MAIN CONTROL BOX -CONFIGURATION Pro-Comm model beds

4 CHANNEL - Pro-Comm style beds

MAIN CONTROL BOX -CONFIGURATION Pro-Care model beds

3 CHANNEL - Pro-Care style beds

MARK 1 (to bed Serial No: 030999)

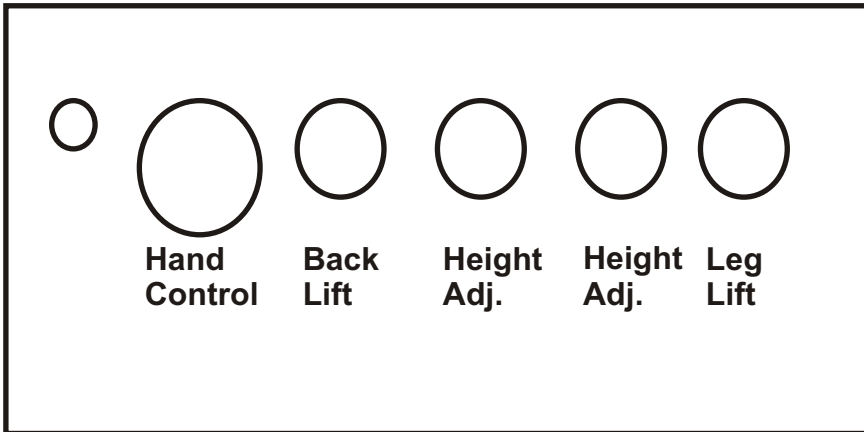
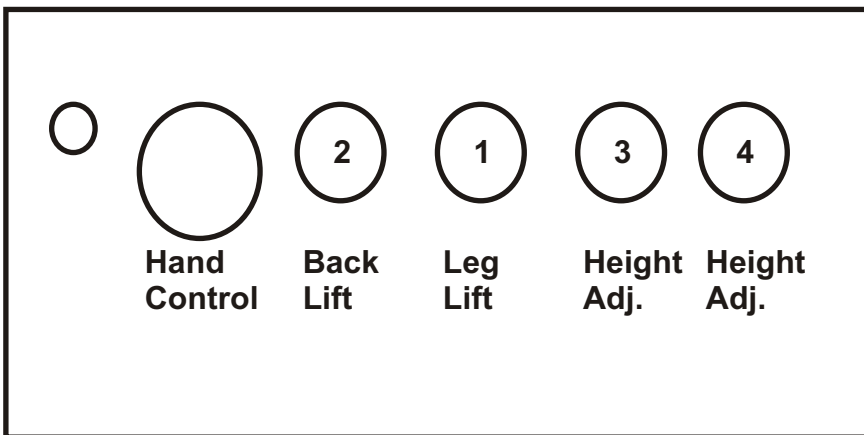
If fitting one of the latest style 4-channel hand control units to a 4-function bed with the earlier Mark 1 Main Control Box then it will be necessary to adjust the actuator plug configuration to match the Mark 2 box shown.

MARK 1 (to bed Serial No: 030999)

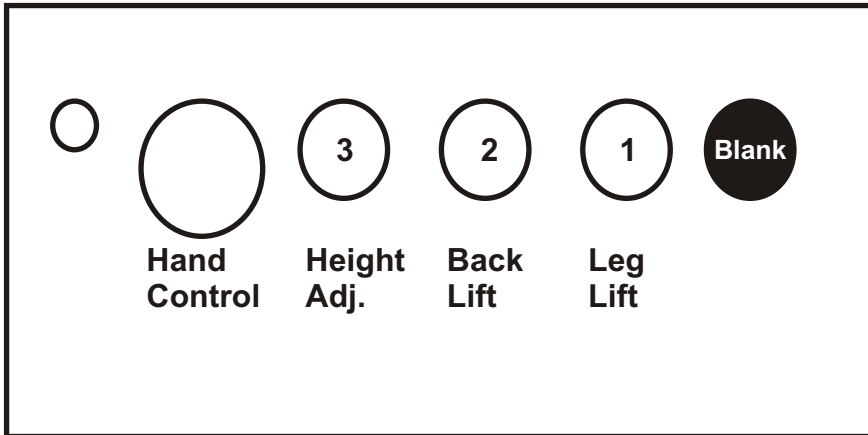
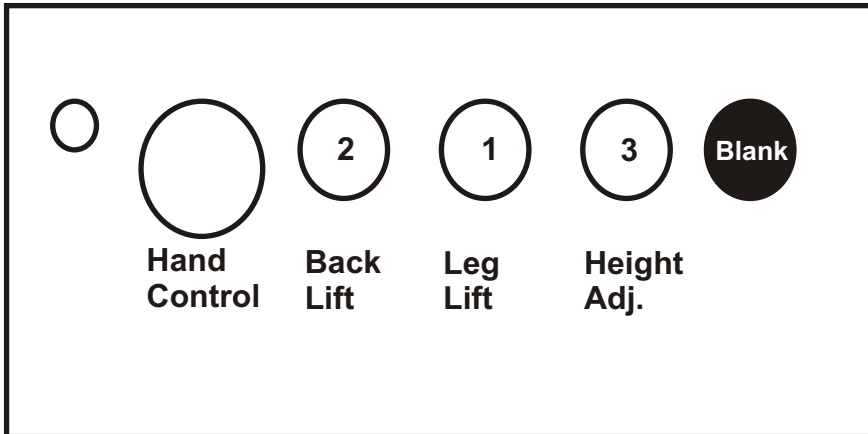
If fitting a replacement Hand Control or Main Control box to an earlier model 3-function bed then it may be necessary to alter the actuator plug configuration to ensure that the button presses are matched to the selected bed function. **NOTE:** on Mark 2 & Mark 3 versions the 'spare' socket is blanked using a removable insert (on Mark 1 versions there is no spare socket).
